SUBJECT: LaSalle County Nuclear Power Station Unit 2
Request for Emergency Technical Specification Amendment
Facility Operating License NPF-18
Emergency Safety/Relief Valve Opening Setpoint Tolerance Change
NRC Docket No. 50-374

ATTACHMENT A

DESCRIPTION AND SAFETY ANALYSIS OF THE PROPOSED CHANGES

FIGURE 1

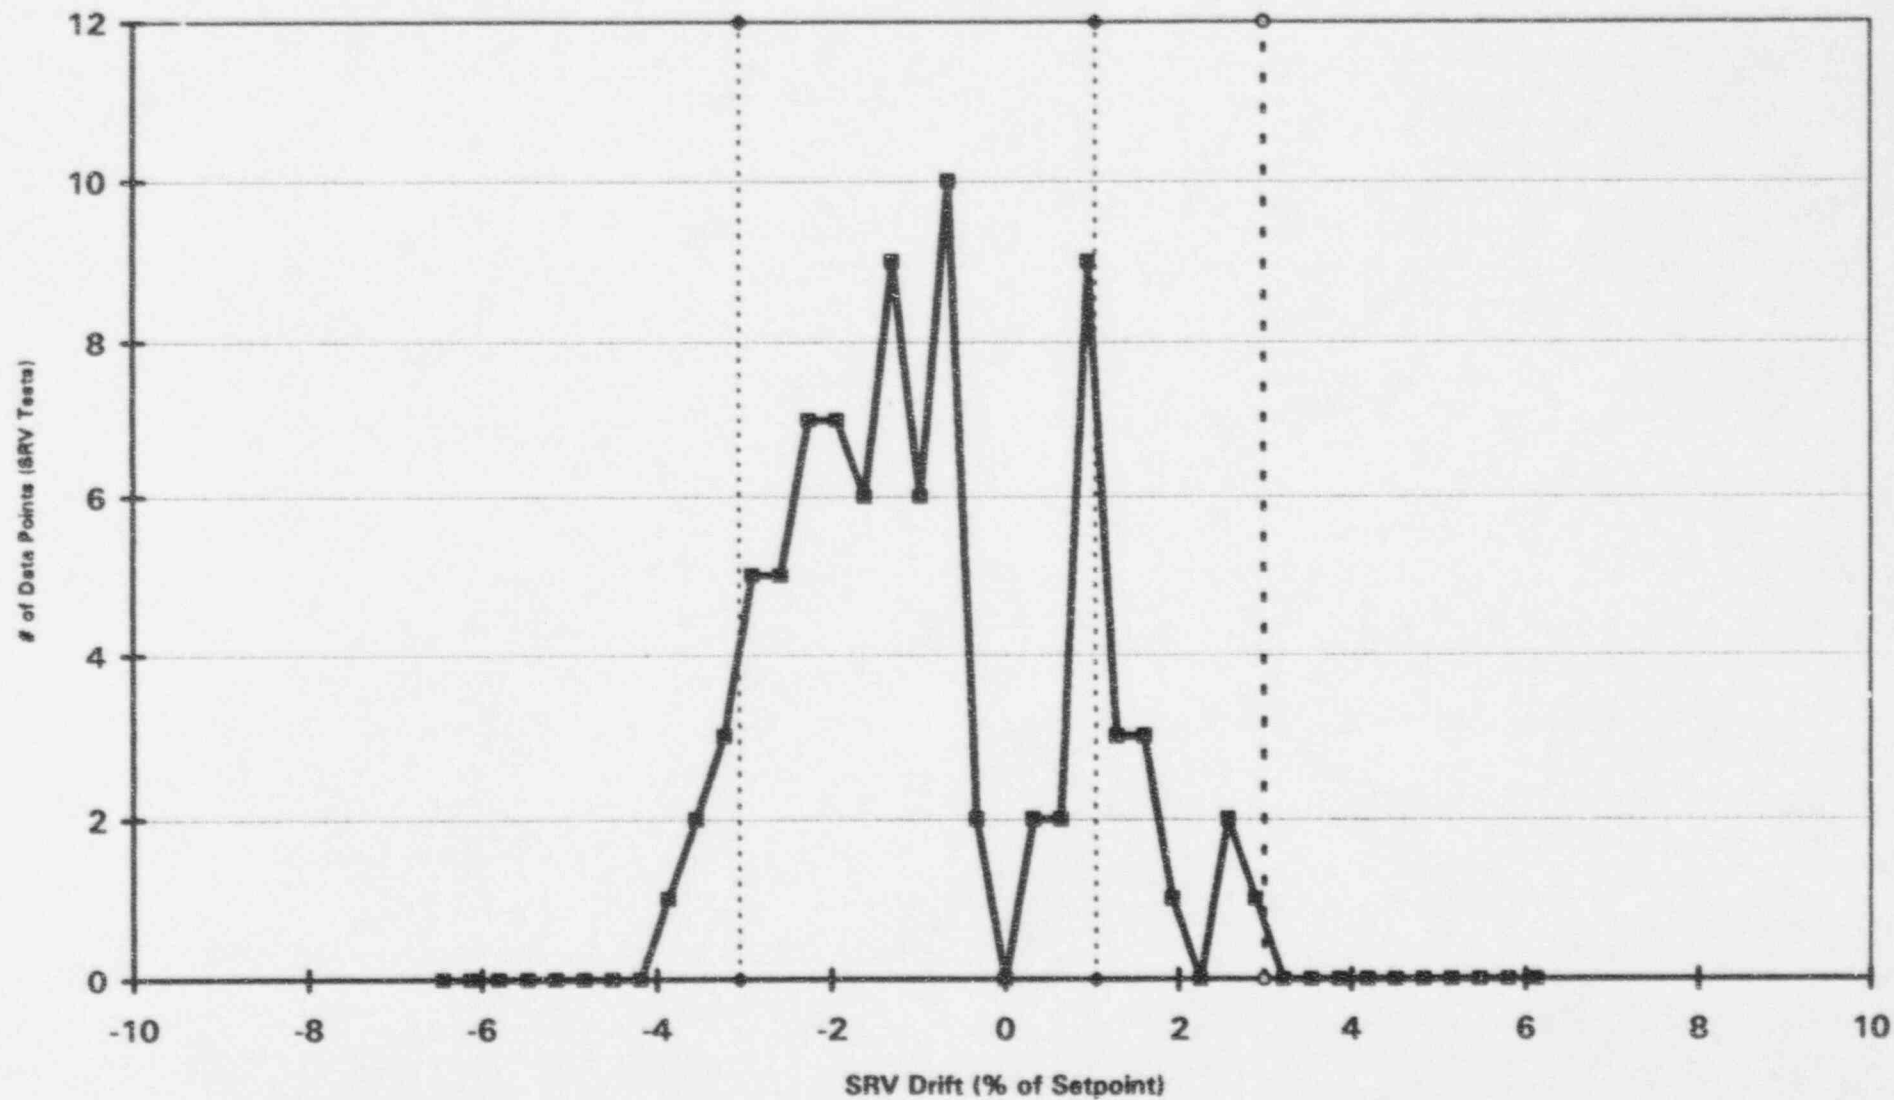
tests showed that two of the additional three valves tested, also opened at pressures outside of the allowable tolerances. All of the four valves that failed, lifted at pressures greater than 1% above the nominal safety function lift settings. A summary of the historical valve testing data through the current Unit 2 refueling outage is shown in Figure 1. Each test value shown in this graph represents the worst of the first four tests for a given valve during one testing cycle. Data demonstrate the historical as-found opening setpoints for LaSalle Station follow an expected statistical distribution.

Of the six valves in the initial sample, whose results were obtained March 18, two were considered as-found failures per the LaSalle testing procedure. However, only one failed on the initial lift. The other valve was within tolerance on the first lift, but failed the second and third lifts (the lift pressure on the third lift was 3.3% above the valve setpoint). Of the three valves tested subsequently, two valves were considered failures by LaSalle's procedure, but only one failed during the initial setpoint test. Thus, due to LaSalle's conservative testing procedure, four SRVs were considered failures even though, by current industry standards, only two SRVs would be considered failures. None of the first lift failures were above a +3% criterion.
